CITY OF DARIEN
PLANNING, ZONING, AND ECONOMIC DEVELOPMENT COMMISSION

AGENDA MEMO
PLANNING, ZONING AND ECONOMIC DEVELOPMENT COMMISSION
MARCH 5, 2025

PZC2024-14

Special Use Amendment, Variations – 8226 S. Cass Avenue

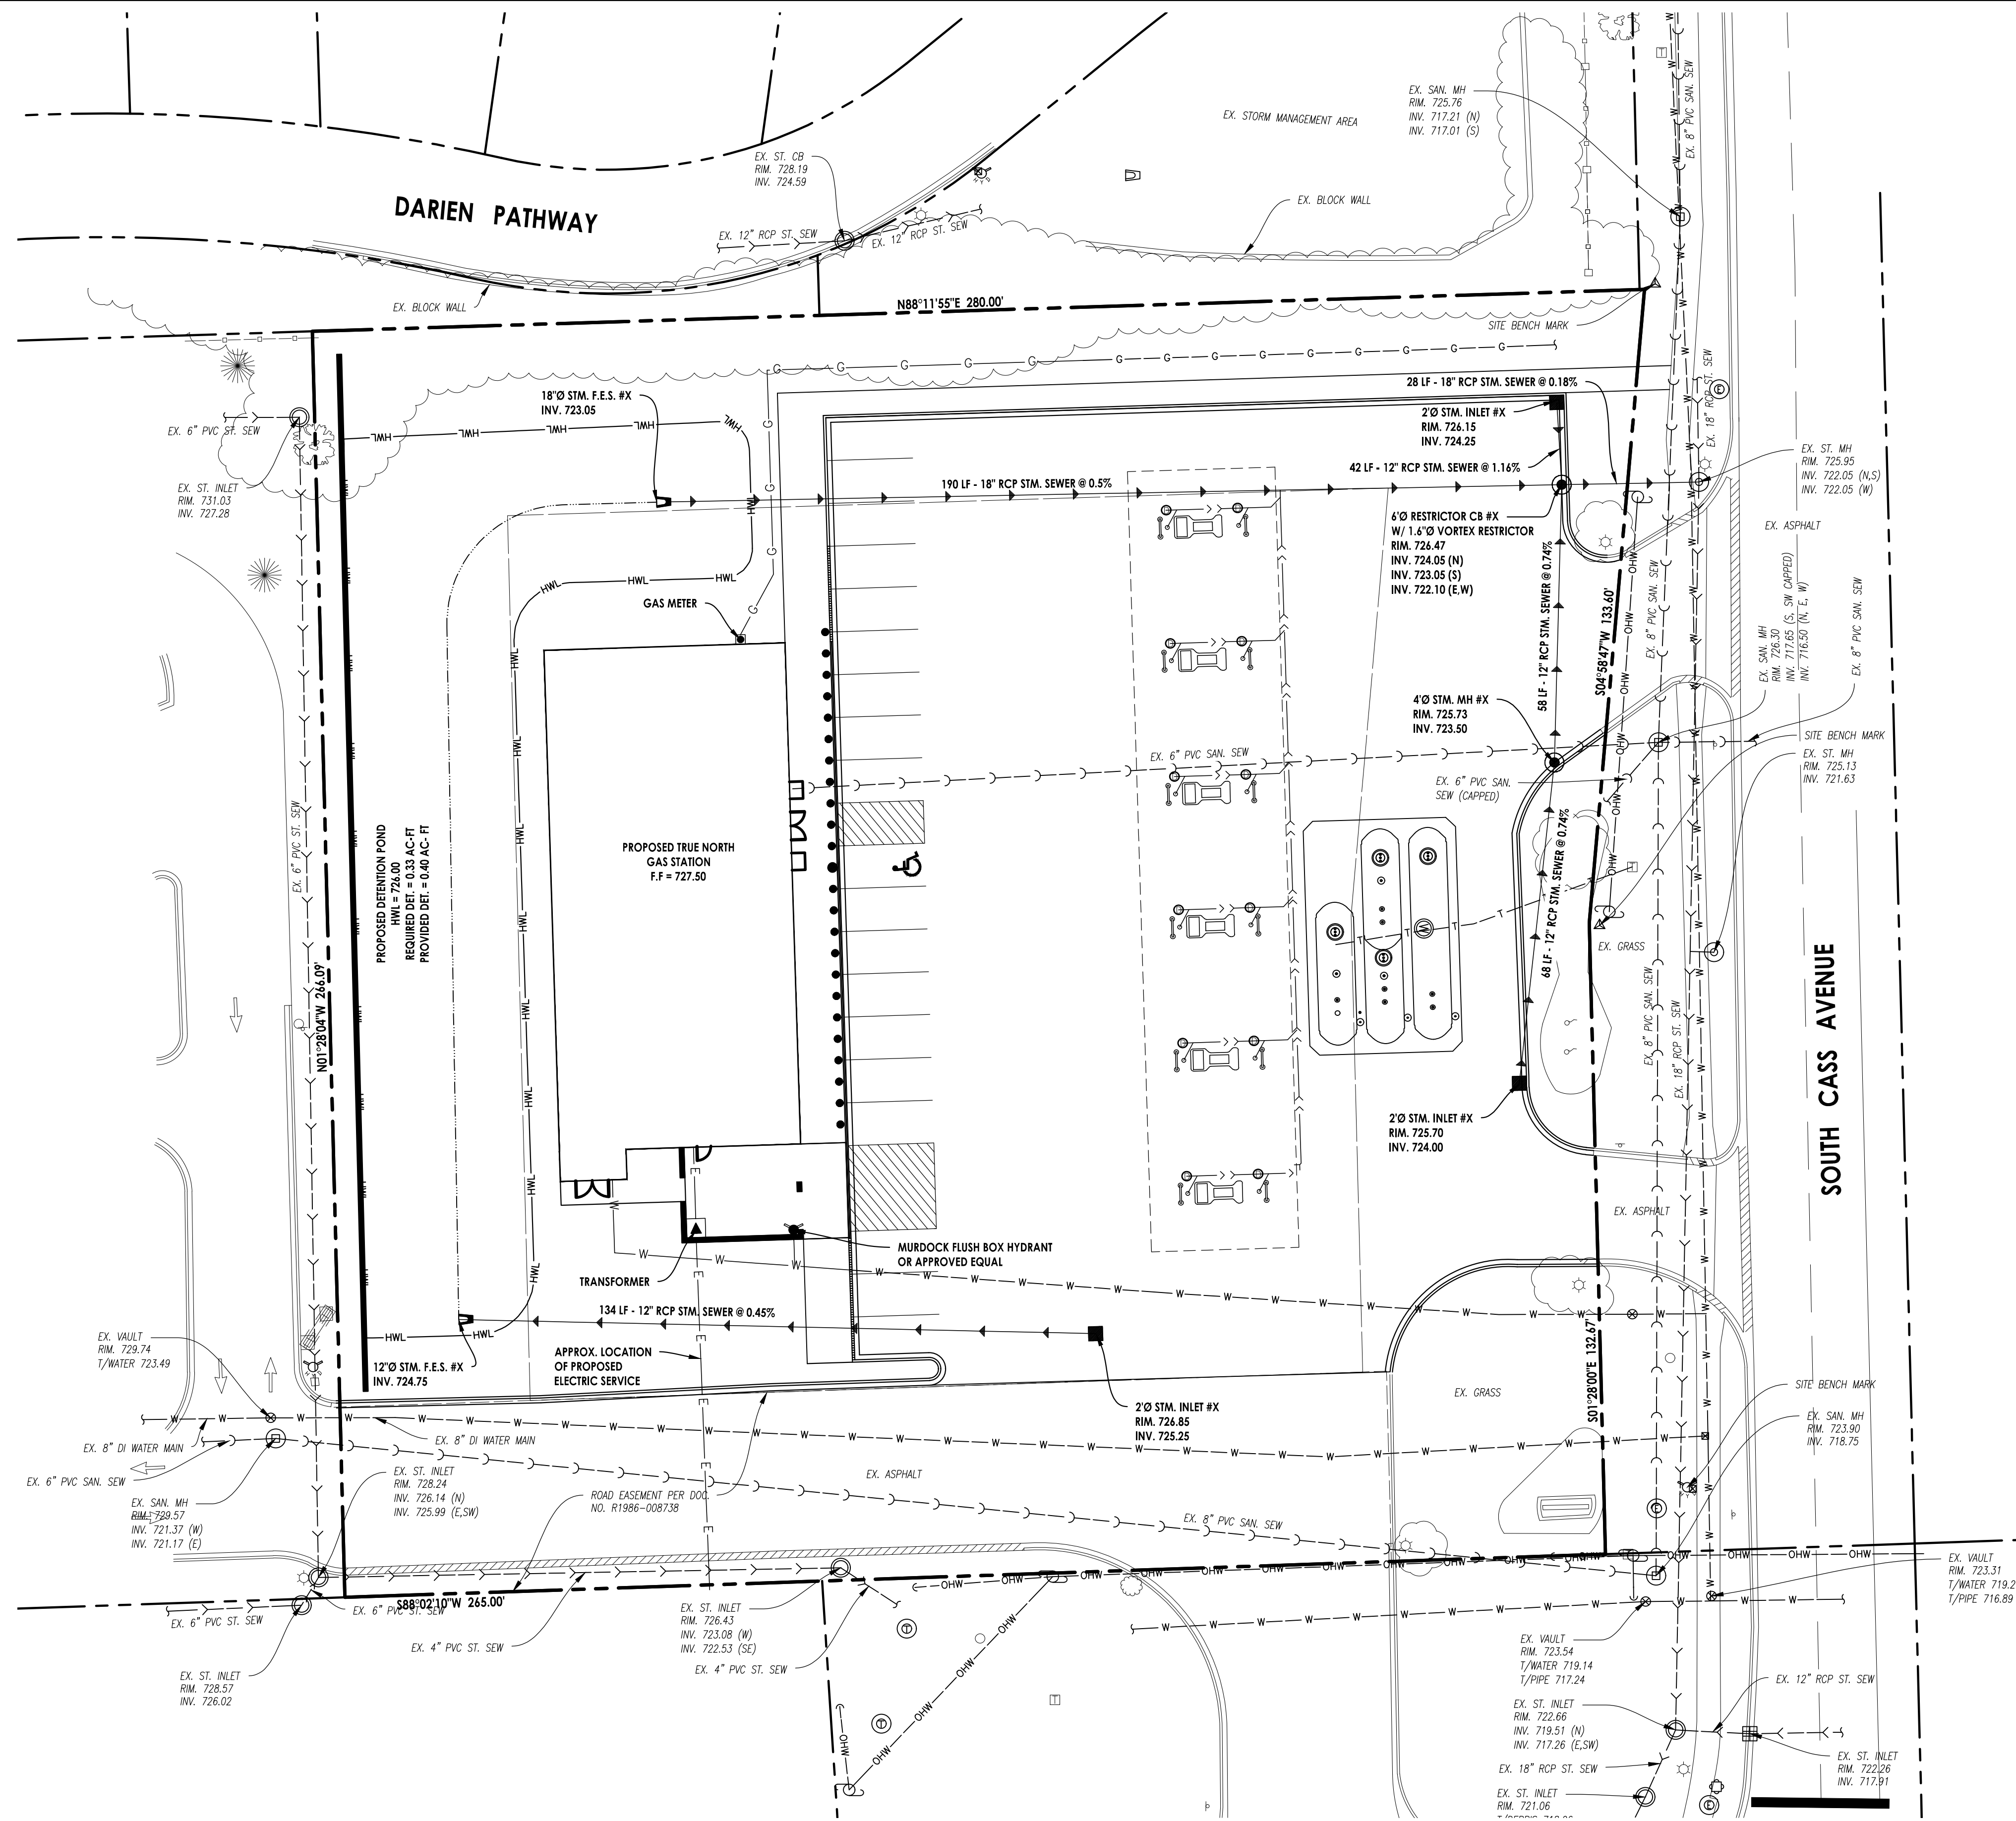
Sheet C2.0

SHEET No. C3.0

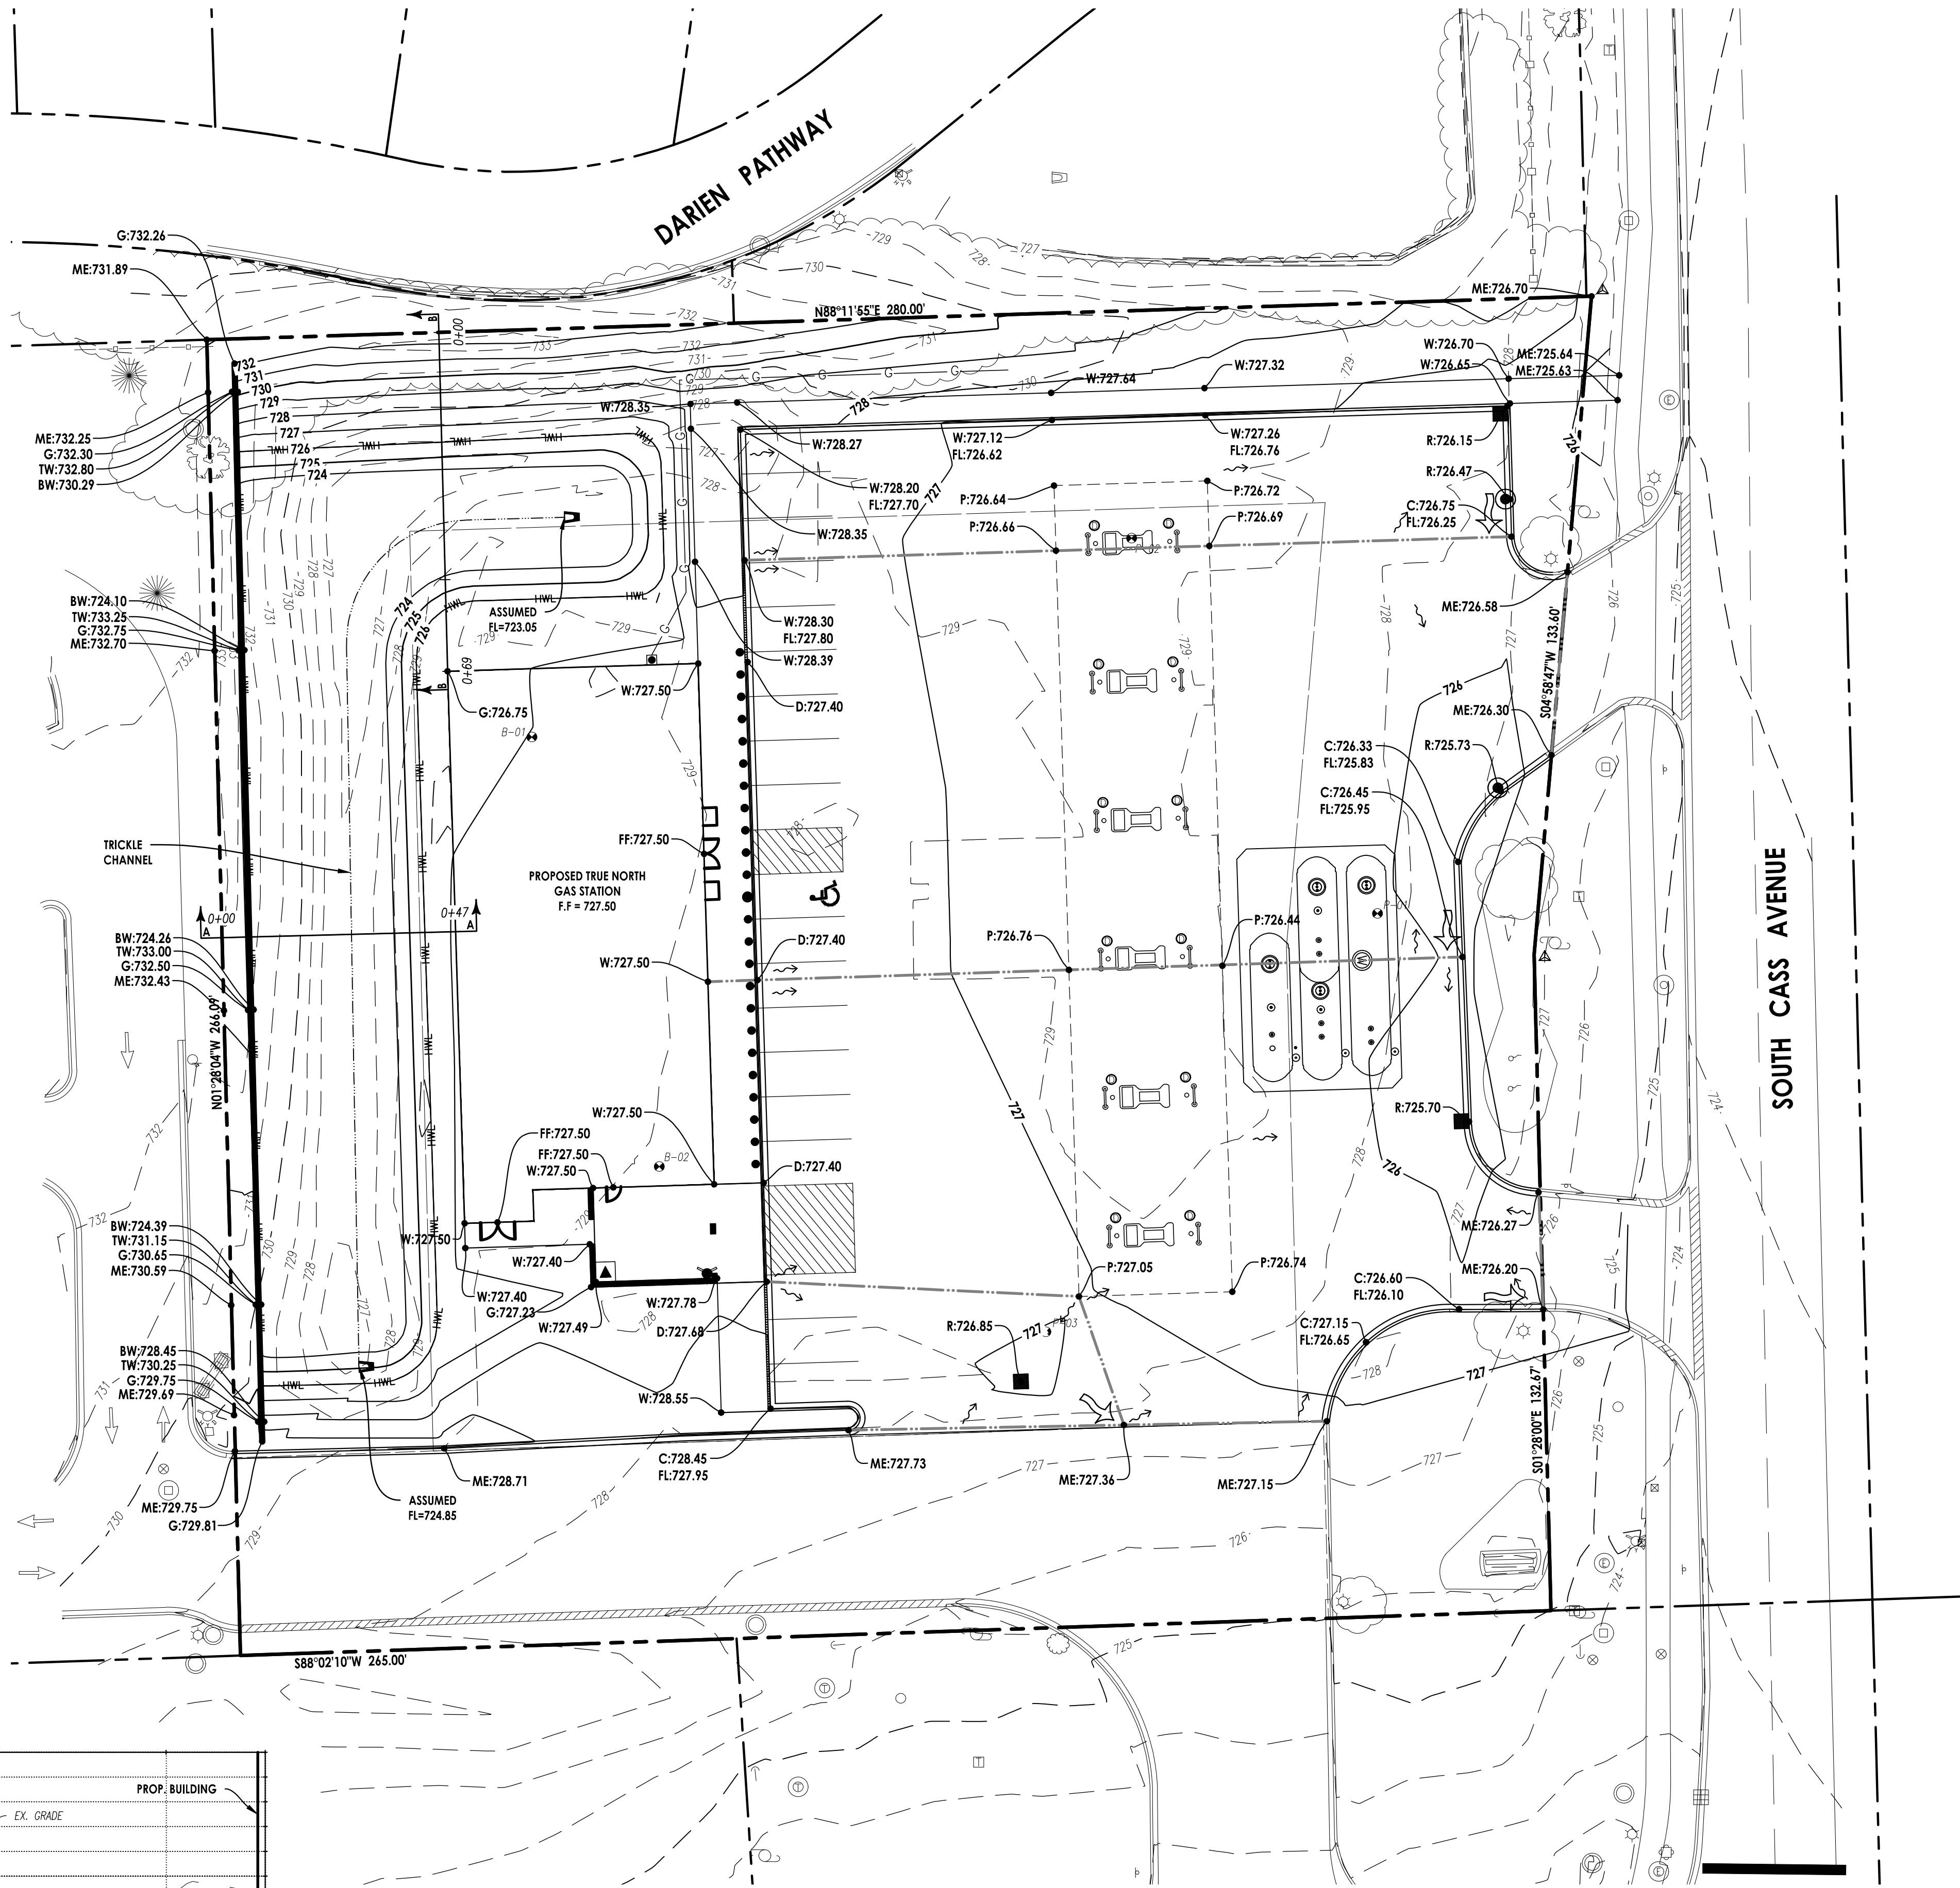
7. Provide the vertical crossing elevations for all proposed utility crossings.
8. The proposed 42 LF 12" RCP storm sewer when measured is only 16 LF. This typo should be revised to the correct length.
9. The slope for the 58 LF RCP storm sewer is calculated to be 0.78% instead of 0.74%. Verify and revise accordingly.
10. The slope for the 134 LF RCP storm sewer is calculated to be 0.37% instead of 0.45%. Verify and revise accordingly.
11. Provide the proposed rim and invert elevations, the proposed slopes, and connect invert to the proposed 18" storm sewer.
12. We note that an existing telecommunications line is located within the footprint of the proposed underground storage tanks and will likely need to be removed and relocated.
13. Callout the relocated water service from the connection point to the building. Also provide the material and size of the water service.

SHEET NAME	GRADING PLAN
PROJECT NAME	TRUENORTH
PROJECT No.	TN 984
SHEET No.	C4.0
PROJECT ADDRESS	8226 CASS AVE. DARIEN, IL
OF 13 SHEETS

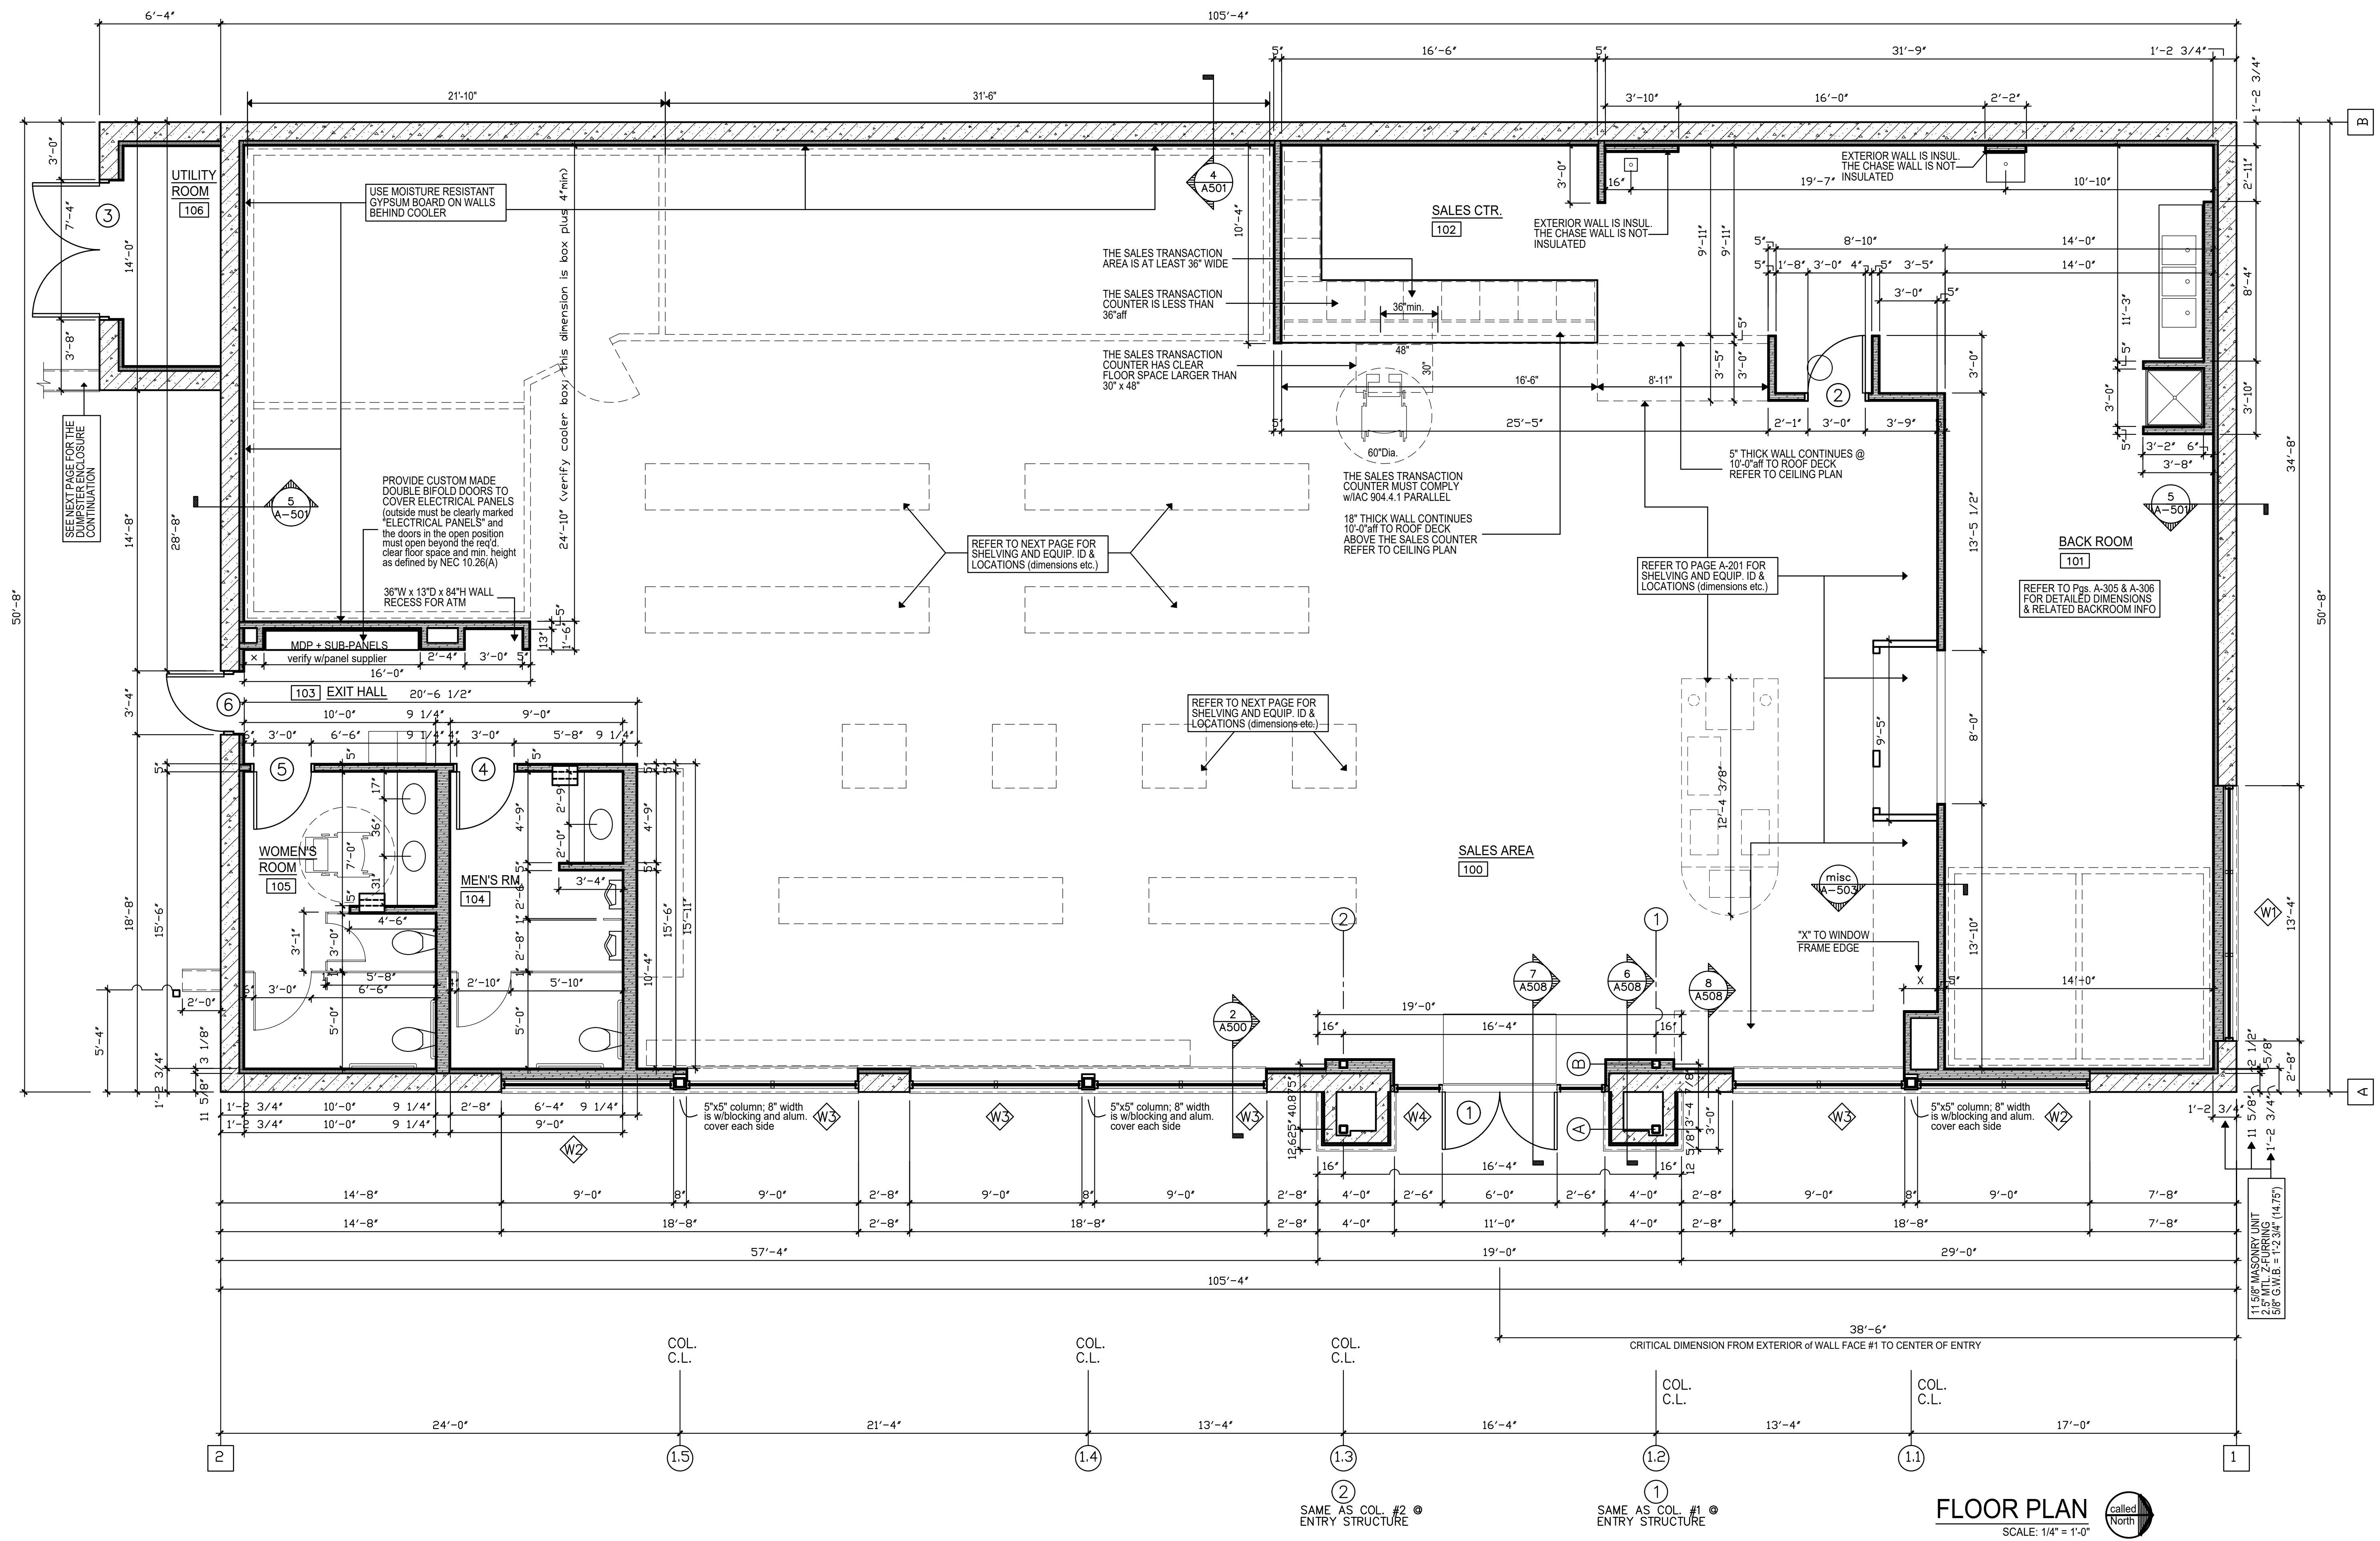
Sheet C4-0
